Re. Sub-division of plot No. 2, K-17,
Lyari Quarter.

PLAN OF EXISTING BUILDING SHOWING PROPOSED
SUB-DIVISION ON PLOT No 5 SHEET RB-7 RAMBAUGH & R
Scale 8" = 1"

PLAN
SHOWING PROPOSED BUNGALOW
ON PLOT NO 21 SHEET NO J-M-1.
JANGHED QUARTER.
SCALE 3"=1."

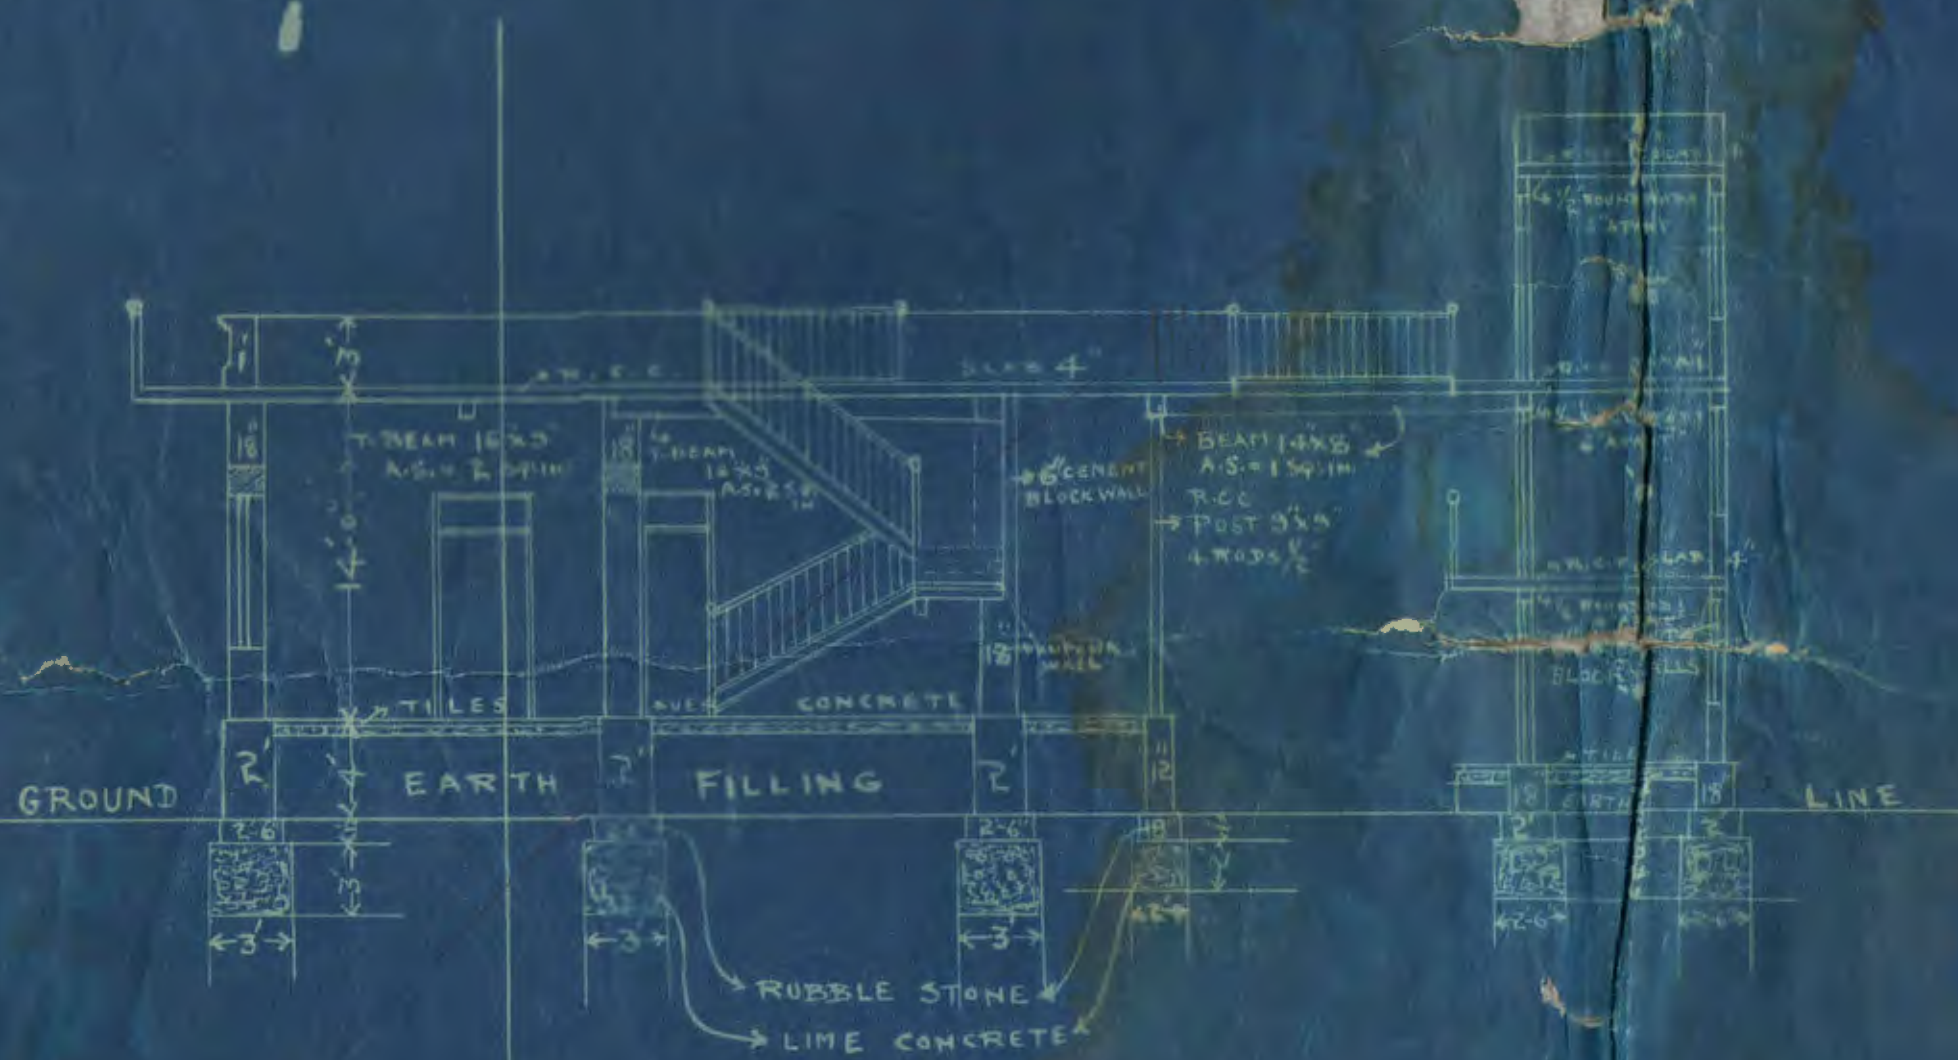
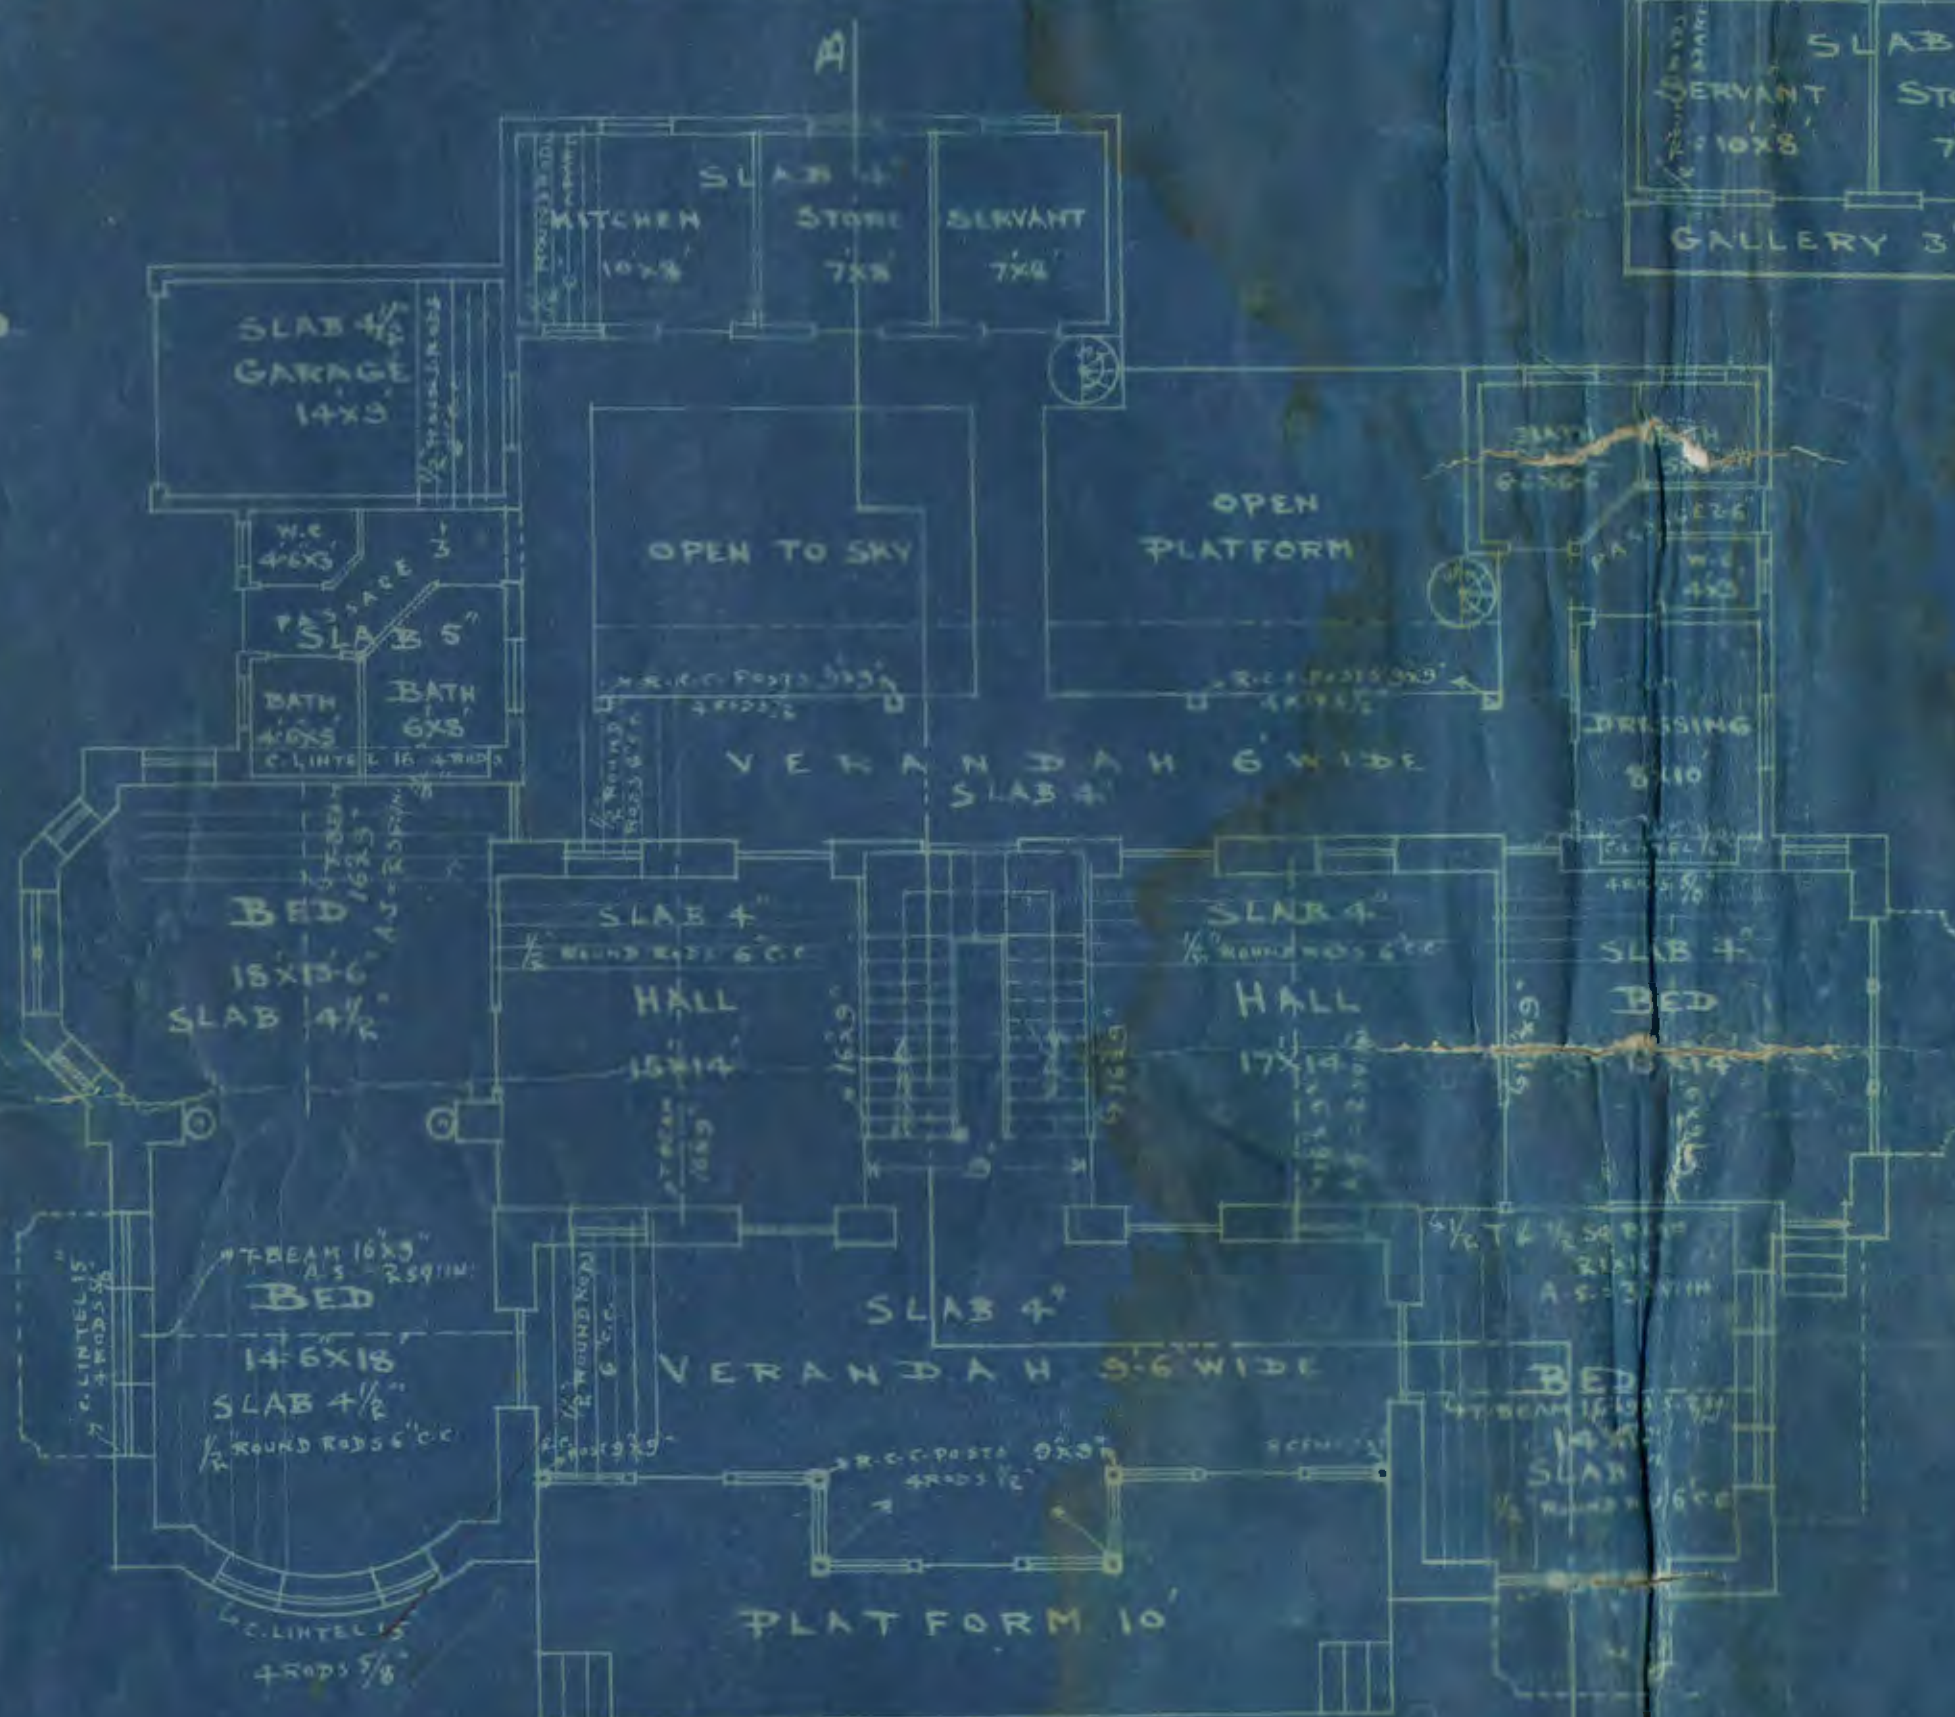
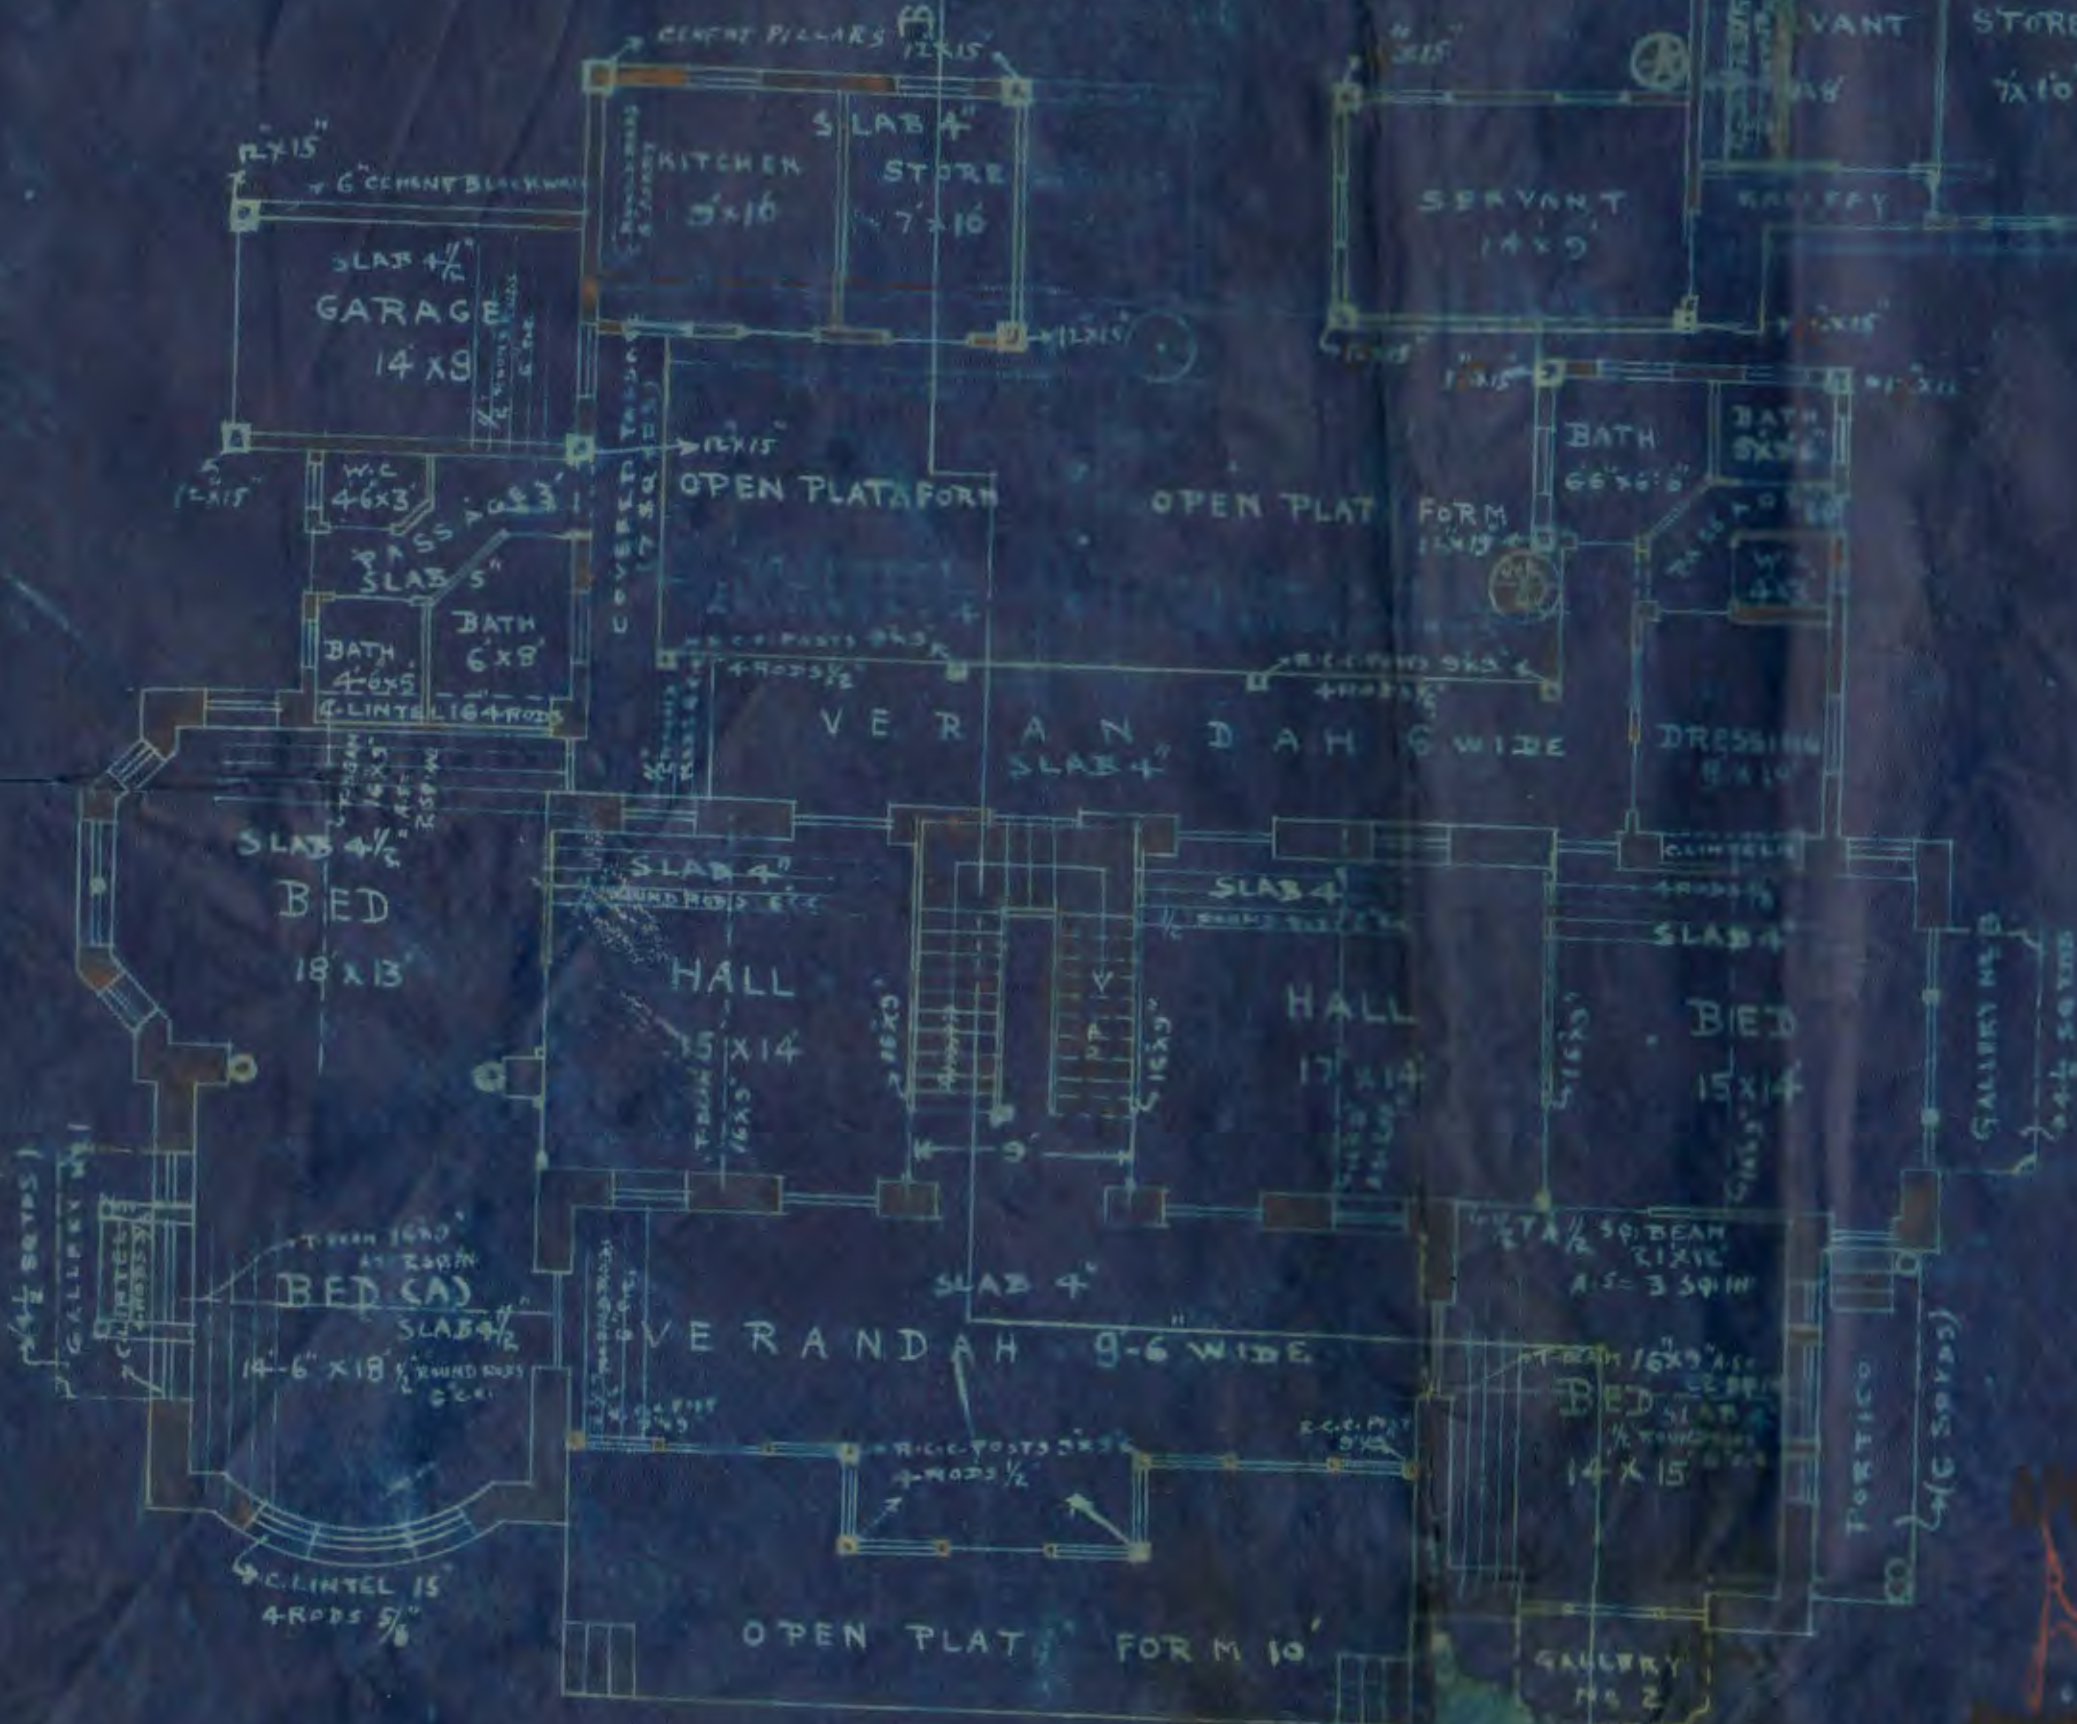
- (1) Section & elevation of reinforcement ^{plans} and calculation thereof should be submitted Calculated
- (2) Walls of out-house also should be measured.
- (3) ~~Building~~ Building area is more than $\frac{1}{2}$
- (4) ~~Size~~ ^{Size} ~~Measure~~ of building shall be specified.

(1) The gallery which was added to white have been deleted by him(2) Rec. box detail right to be given before with calculations.(3) Section of building is not given.Date 13.12.24S. L. N. amr
Building Surveyor.

According to the conditions of sale of the plot, not more than 1/3rd of the area of the plot shall be occupied by buildings, but the area of building in respect of this plot according to the plan submitted by the owner is 411 sq. yds including area of projecting balconies and is therefore more than one third area as per conditions of sale. *area of plot is 1094 1/2 sq. yds + 1/3rd is 365 sq. yds*

The area of building according to the plan submitted by the owner is 411 sq. yds including area of projecting balconies and is more than one-third the area of the plot, the latter being 10742 Sq. Yds. ~~It is~~ contention of the owner that the area of the balconies should not be included in the area of building is not valid. According to the ^{plan} ~~sale condition~~ ^{of the plot} which reads ~~as under~~, ^{the} open space must not have any balcony or similar projection on it, according to the H.C. condition.

The Architect has have necessary correction on section originally submitted & the plans may now be approved, as there is no objection.
